TMI-20-005

Three Mile Island Nuclear Station, Unit 1  
Renewed Facility Operating License No. DPR-50  
NRC Docket No. 50-289

**Subject:** Response to Request for Additional Information Related to License Amendment Request for Proposed Changes to the Three Mile Island Nuclear Station Permanently Defueled Emergency Plan and Emergency Action Level Scheme

**ATTACHMENT 1**  
**Response to Request for Additional Information**

**Figure 6.1: Exelon Notification Scheme**

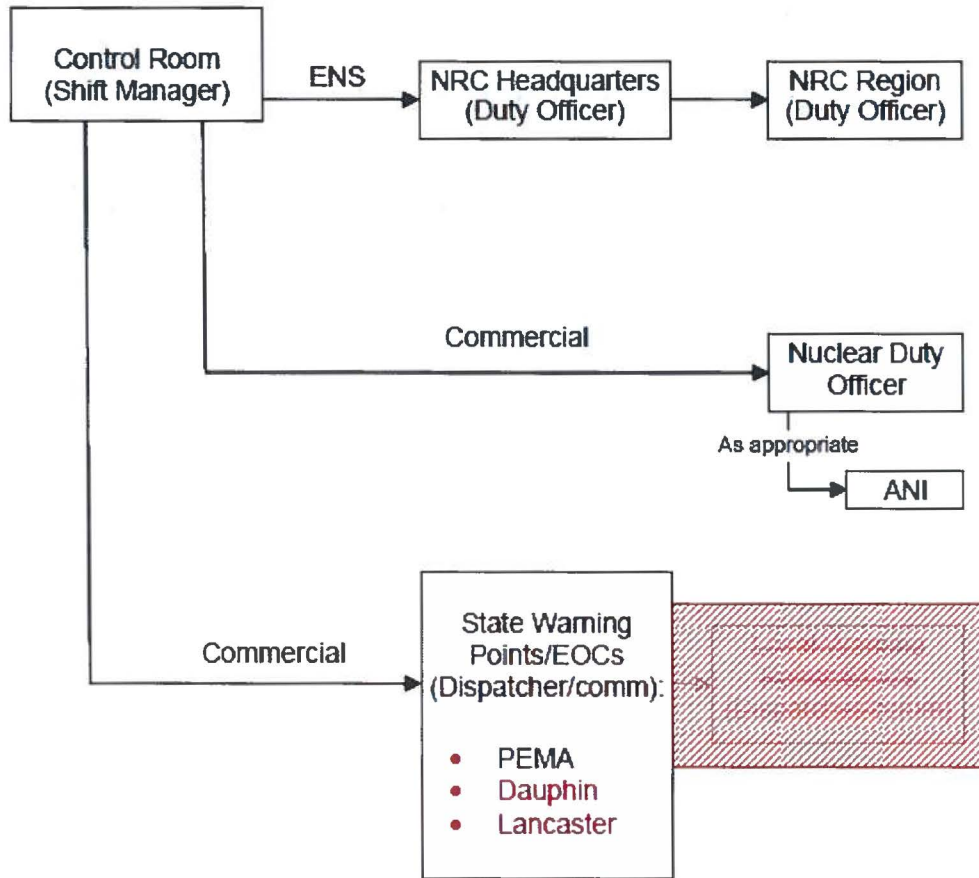
Figure 6.1 "Exelon Notification Scheme," (page 19) in Attachment 2 of Exelon's July 1, 2019 letter, also indicates the Commonwealth of Pennsylvania – PEMA [Pennsylvania Emergency Management Agency] – will provide notification to "Local Warning Points/EOCs [Emergency Operations Centers]."

Please clarify which responsible government agencies (local warning points/EOCs) will be notified by PEMA in the event of an emergency declaration at TMI, and documentation of agreement with these local response organizations on this approach following permanent cessation of power operations.

purposes of Emergency Planning, the EAB and the Site Boundary are considered the same. The EAB is entirely encapsulated in Dauphin County. However emergency response (e.g. Fire Fighting and Emergency Medical) is provided by both Dauphin and Lancaster Counties. Therefore, Exelon is proposing modifying the notification protocol to also include the local agencies (Dauphin and Lancaster Counties), as well as the Lead Agency (PEMA), within 30 minutes. The proposed change is consistent with the current notification performed to risk counties, except for a revision to the affected counties (i.e., Dauphin and Lancaster Counties). The proposed protocol to these counties remains consistent with current protocol, and as noted in the PDEP Attachment 4, PEMA maintains the letters of agreement with the counties.

Exelon proposes the following changes to Section 2.6 and Figure 6.1 of the PDEP submitted in Reference 2. (Additions are shown in ***bold-italics*** and deletions are shown in ~~***bold-italics-strikethrough***~~.)
